MONROE COUNTY, NEW YORK

ADDENDUM NO. 1

**MONROE COMMUNITY COLLEGE
2011 WINDOW REPLACEMENT AND CONCRETE/BRICK REPAIR
DECEMBER 2010
Bids Due: January 6, 2010 at 2:00 PM,**

Prepared by:
DeWolff Partnership Architects LLP
151 St. Paul Street
Rochester, New York 14604

1 GLAZING JAMB / MULLION - TYPICAL
SCALE: 1 1/2" = 1'-0"
REFERENCE LOCATION ● CONF/LOUNGE
SIMILAR ● PRES. OFFICE & BOARD RM

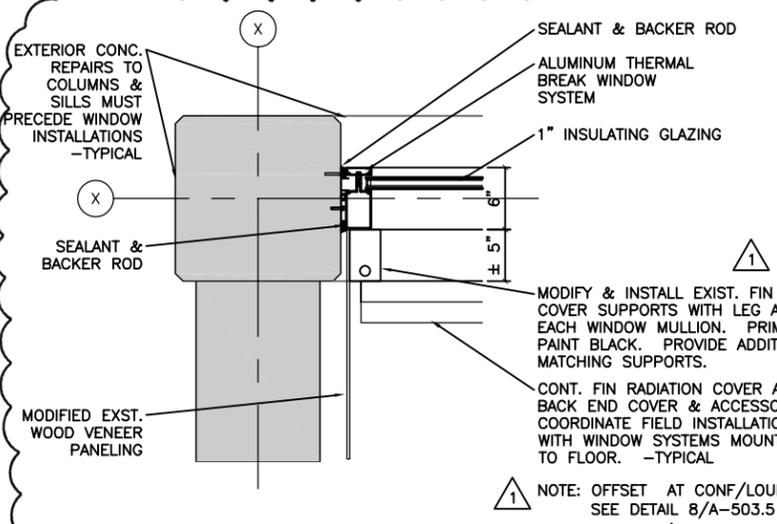
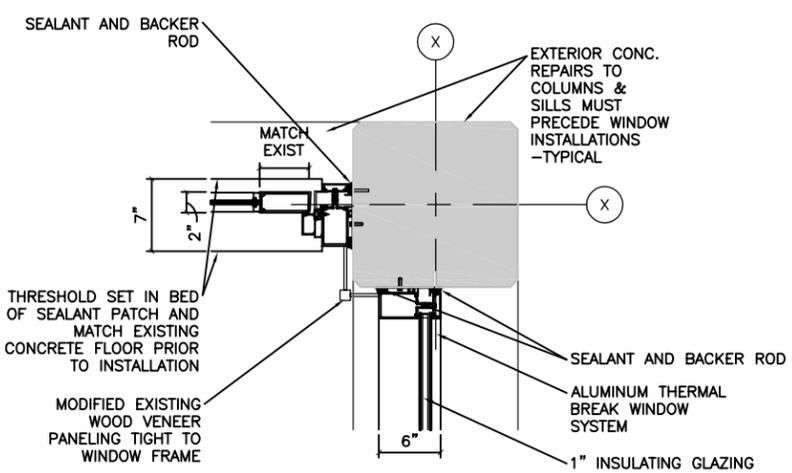
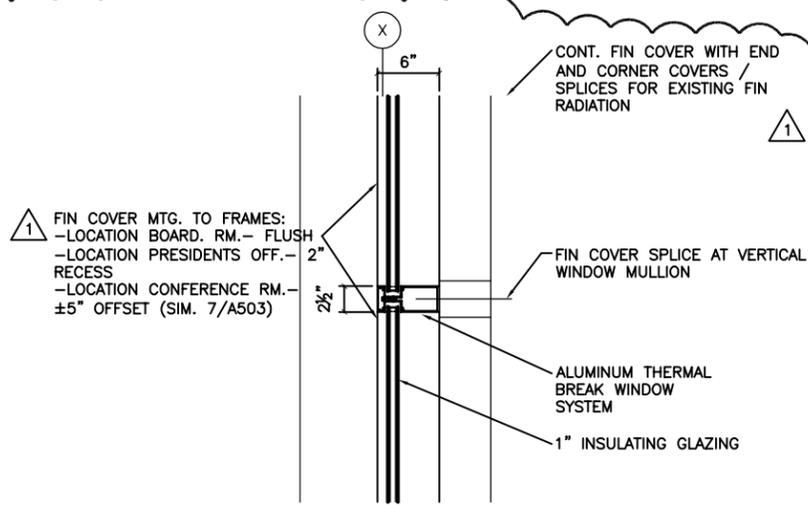
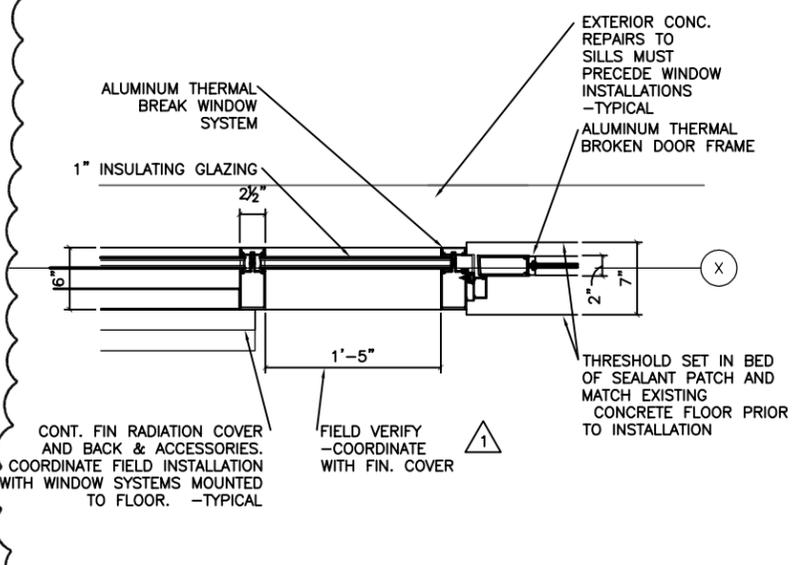
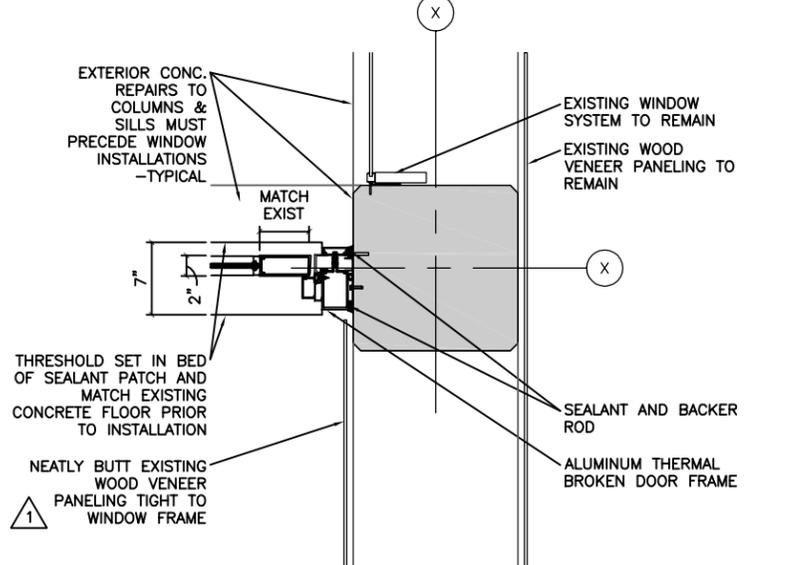
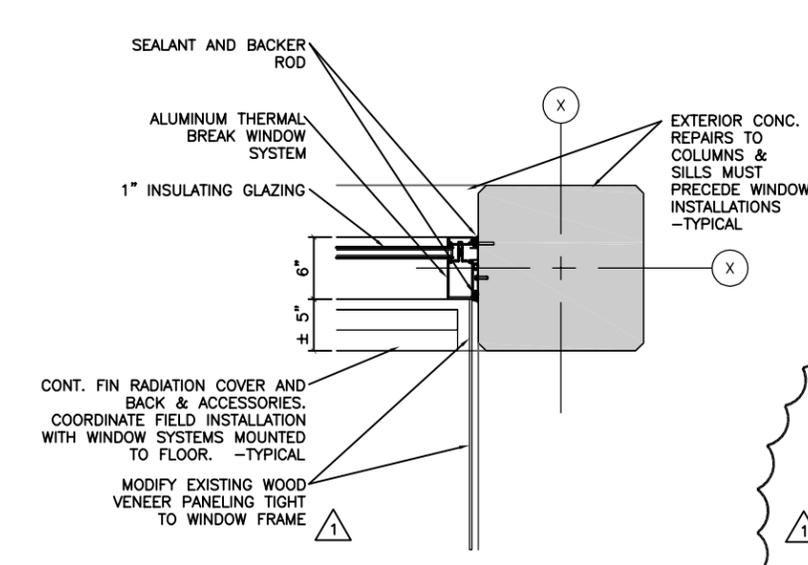
- 1-107 Details 1, 2, 3, 4, 5 & 6 /A-503.5:
ADD: REPLACE DETAILS 1, 2, 3, 4, 5 & 6 /A-503.5 WITH ATTACHED DETAILS 1, 2, 3, 4, 5 & 6, AS FOUND ON ADDENDUM 1 DRAWING 1-107. CLARIFICATION.
- 1-108 Details 7 & 8 /A-503.5:
ADD: REPLACE DETAIL 7/A-503.4 AND ADD DETAIL 8/A-503.8 WITH ATTACHED DETAILS 7 & 8, AS FOUND ON ADDENDUM 1 DRAWING 1-108. CLARIFICATION.

1-109

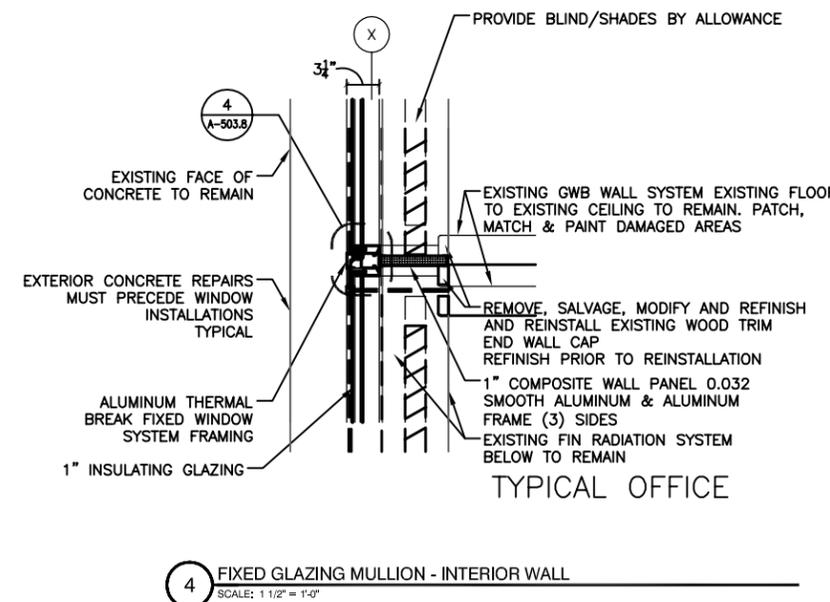
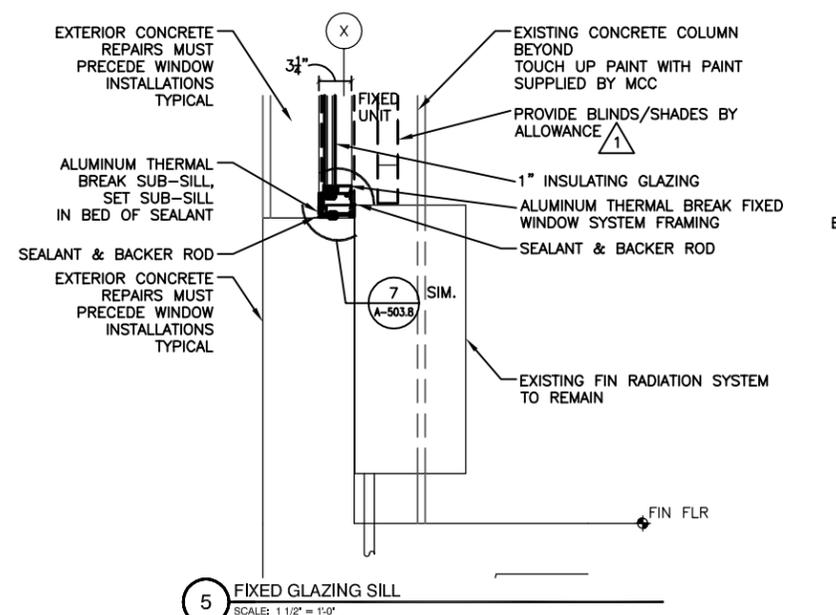
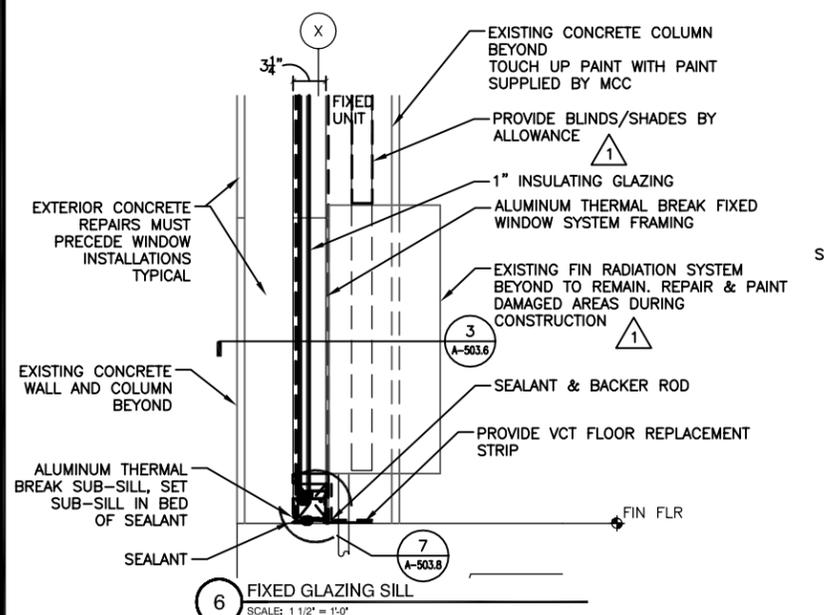
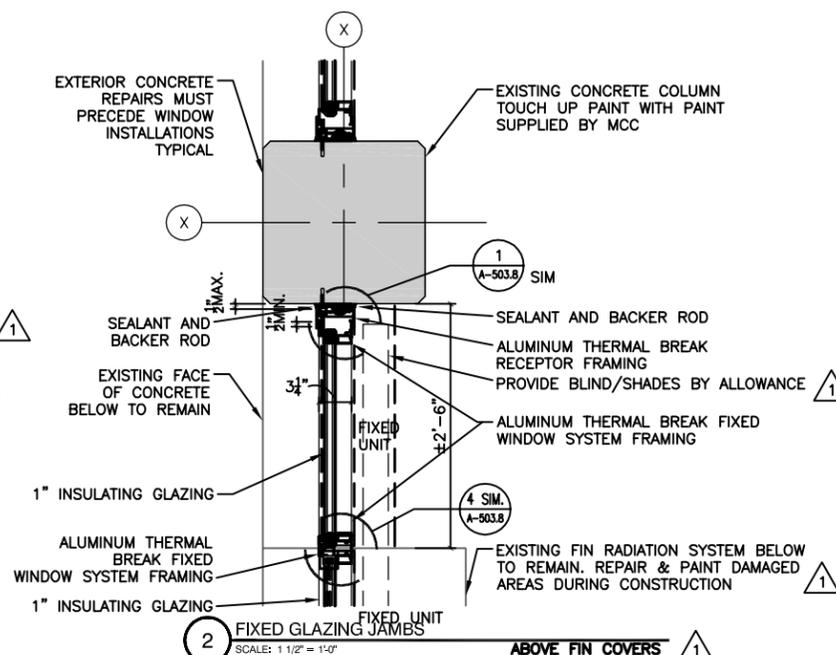
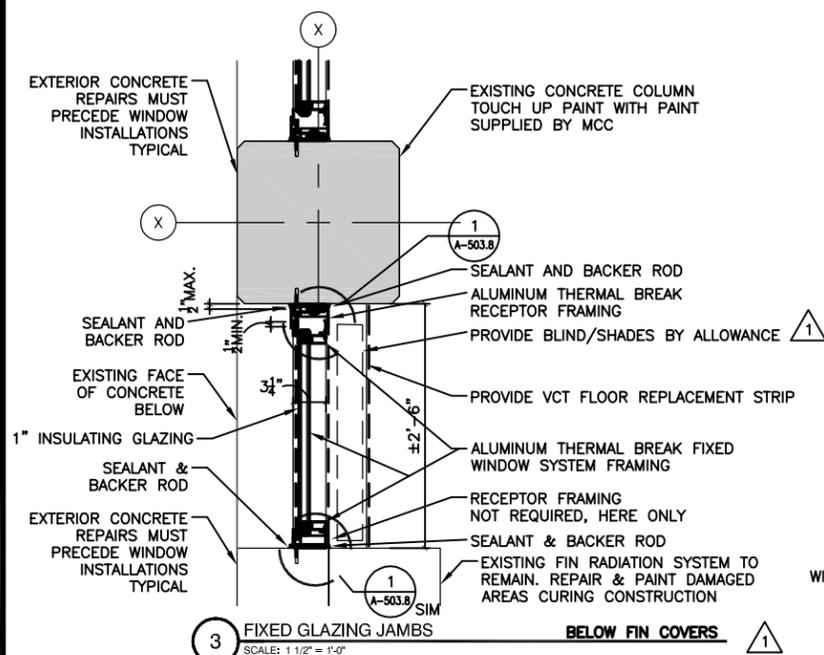
- 1-109 Details 1, 2, 3, 4, 5 & 6 /A-503.6:
ADD: REPLACE DETAILS 1, 2, 3, 4, 5 & 6 /A-503.6 WITH ATTACHED DETAILS 1, 2, 3, 4, 5 & 6, AS FOUND ON ADDENDUM 1 DRAWING 1-109. CLARIFICATION.
- 1-110 Details 7, 8 & 9 /A-503.6:
ADD: REPLACE DETAIL 7, 8, & 9 /A-503.6 WITH ATTACHED DETAILS 7, 8 & 9, AS FOUND ON ADDENDUM 1 DRAWING 1-110. CLARIFICATION.

1-112

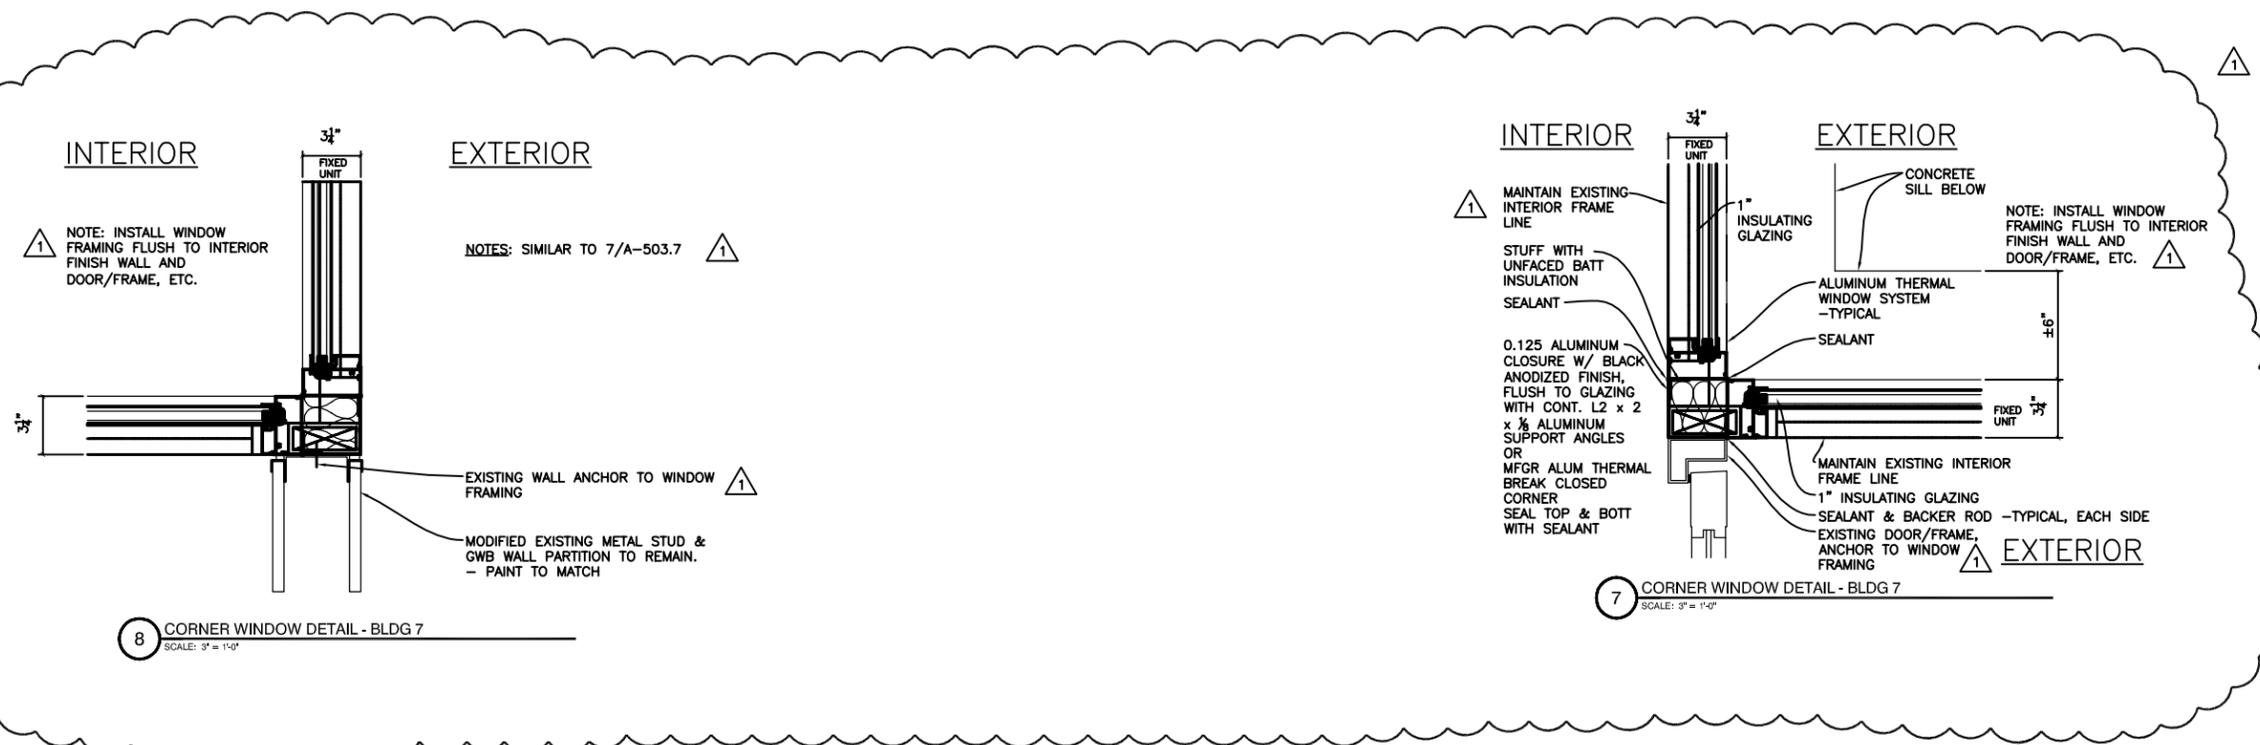
- 1-111 Details 1, 2, 3, 4, 5 & 6 /A-503.7:
ADD: REPLACE DETAILS 1, 2, 3, 4, 5 & 6 /A-503.7 WITH ATTACHED DETAILS 1, 2, 3, 4, 5 & 6, AS FOUND ON ADDENDUM 1 DRAWING 1-111. CLARIFICATION.
- 1-112 Details 7 & 8 /A-503.7:
ADD: REPLACE DETAIL 7 & 8 /A-503.7 WITH ATTACHED DETAILS 7 & 8, AS FOUND ON ADDENDUM 1 DRAWING 1-112. CLARIFICATION.

1-113

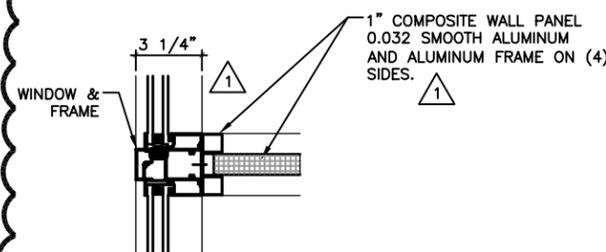
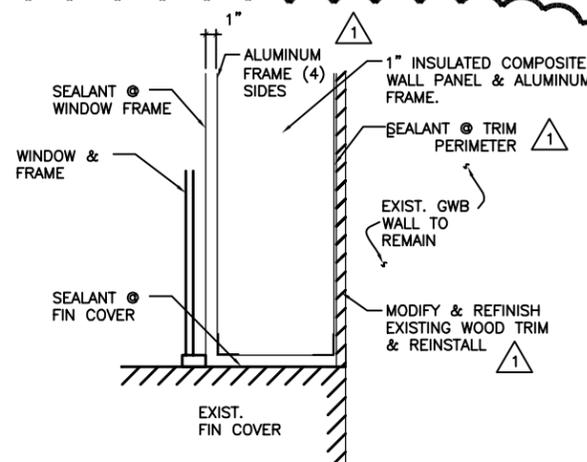
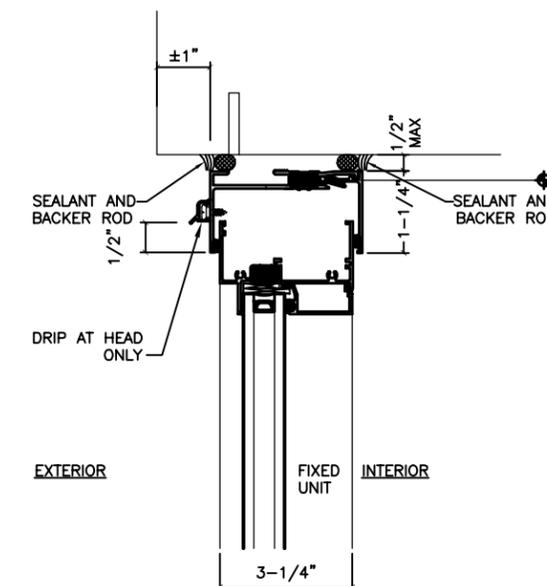
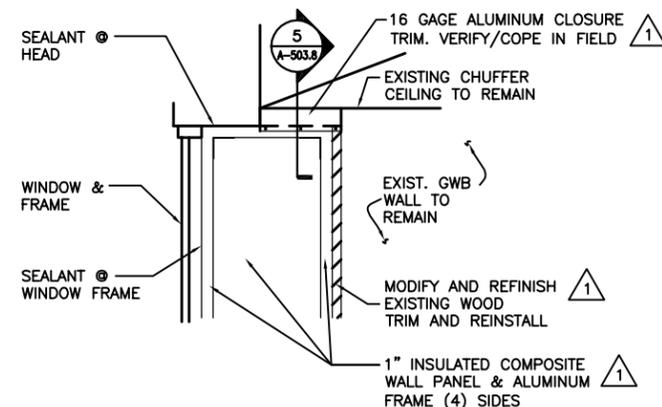
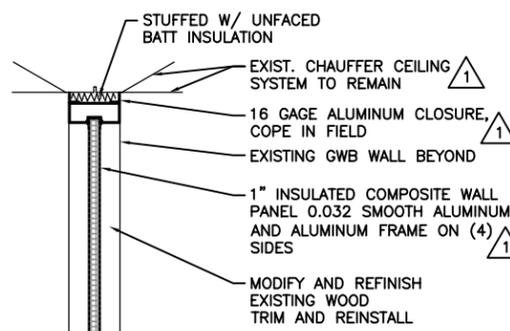
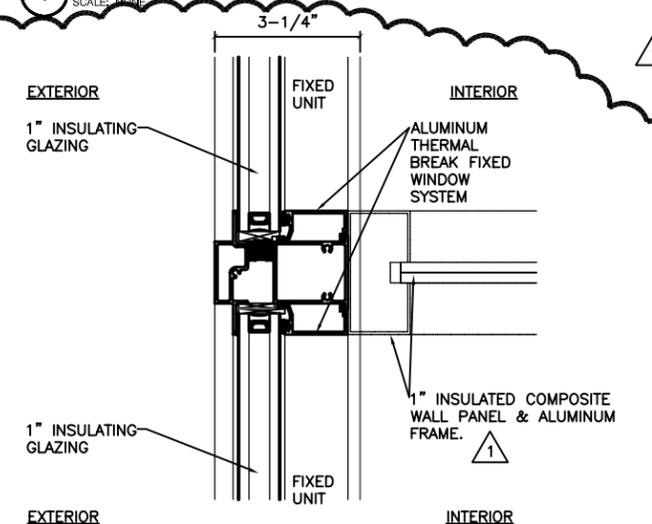
- 1-113 Details 1, 2, 3, 4, 5 & 6 /A-503.8:
ADD: REPLACE DETAILS 1, 2, 3, 4, 5 & 6 /A-503.8 WITH ATTACHED DETAILS 1, 2, 3, 4, 5 & 6, AS FOUND ON ADDENDUM 1 DRAWING 1-113. CLARIFICATION.
- 1-114 Details 7 & 8 /A-503.8:
ADD: REPLACE DETAIL 7 & 8 /A-503.8 WITH ATTACHED DETAILS 7 & 8, AS FOUND ON ADDENDUM 1 DRAWING 1-114. CLARIFICATION.
